Independent Technical Review Report: Idaho Operations

**Review of the Idaho CERCLA Disposal
Facility (ICDF) at Idaho National
Laboratory**

5 December 2007

Fig. 3. Schematic of cover profile planned for the ICDF landfill.

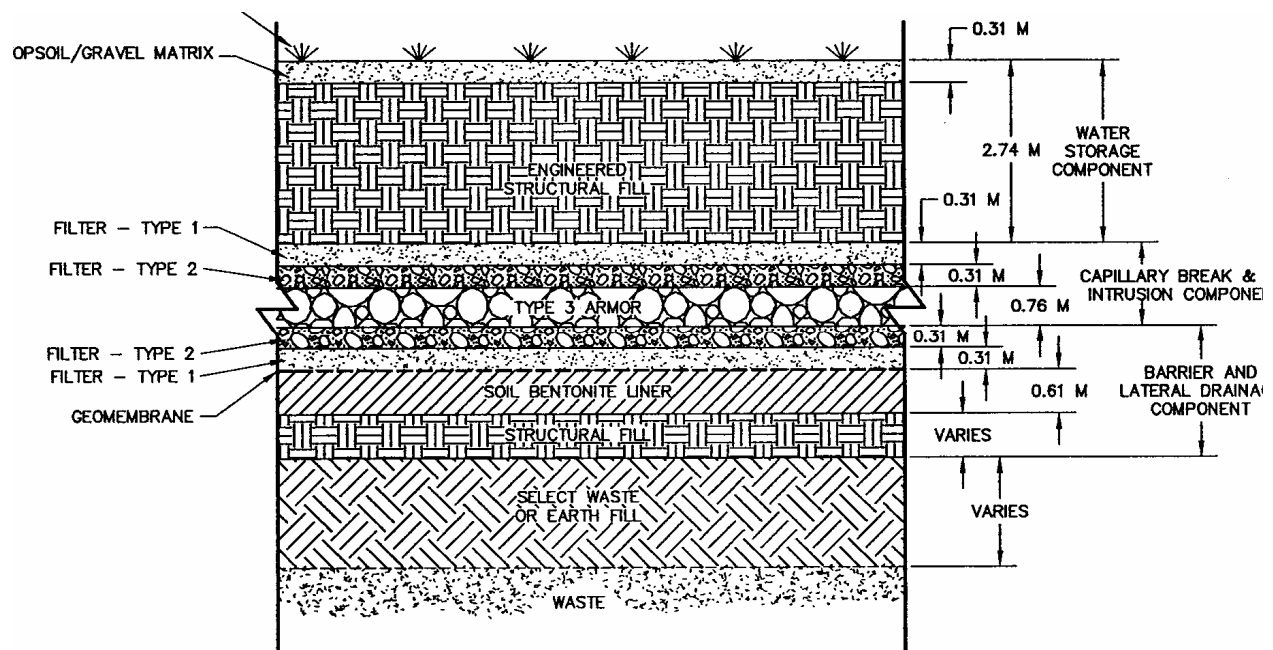
The final cover proposed for the ICDF landfill is more flexible than the Hanford Barrier proposed for Hanford's ERDF. Thus, differential settlement is a less significant concern for the ICDF landfill than at Hanford's ERDF. Nevertheless, the composite barrier at the base of the ICDF cover can be affected by differential settlement. Consequently, the impacts of differential settlement should be evaluated and the methods of waste placement should be reviewed to ensure

A particular concern is that the existing Landfill Compaction/Subsidence Study only accounts for compression of the containment facility and its foundation, and only considers differential settlement over broad distances. Localized differential settlements were not considered and settlement of the waste after placement was assumed to be nil. The ITR team believes that these assumptions are unrealistic given that the stiffness of the waste is likely to vary over a broad range (lowest in areas containing primarily compacted soil, highest in areas that are fully grouted) and that voids existing within and between containers may result in localized settlements due to collapse. Moreover, given the long design life (1000 yr) for the ICDF landfill, long-term creep compression of the waste may be important.

The ITR team recommends that the Landfill Compaction/Subsidence Study be re-evaluated. This re-evaluation should consider the impacts of differential settlement caused by variations in stiffness, collapse of voids, and long-term creep settlement of the various types of waste forms being disposed in the ICDF landfill. This re-evaluation should also include a quantitative linkage between the void space criterion used for grouting and acceptable differential settlements. If this re-evaluation indicates that differential settlement may be problematic, reinforcement of upper and intermediate layers of the waste may be considered (e.g., with grout, geosynthetic reinforcement, or select wastes such as broken concrete, steel beams, or other solid debris). A preloading test may also be considered to quantify the settlement under expected loads applied by the final cover.
